Objection - 2023/0270/P

1790\_EX.06 EXISTING ROCHESTER MEWS ELEV(2).PDF; Problem with proposed.pdf

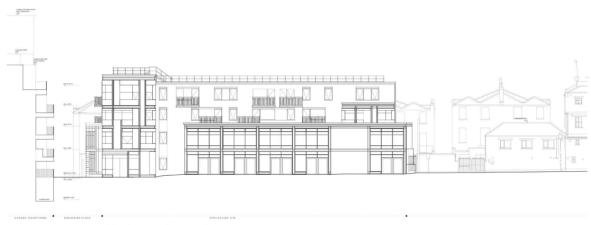
The illumination from the fully glazed top floor will spoil the outlook for some distance around.

Perhaps it is not something the planning team consider, but for us the outlook from another aspect of our house is already spoilt by a fully glazed roof-extension above the surrounding houses on Rochester Place.

Allowing such a wide high-level glazed facade would be detrimental to many houses and would be visible all along the private gardens of Rochester Terrace, as well as being very visible from Rochester Terrace Gardens itself. If light-pollution is yet on your radar, then it would certainly also be an issue.
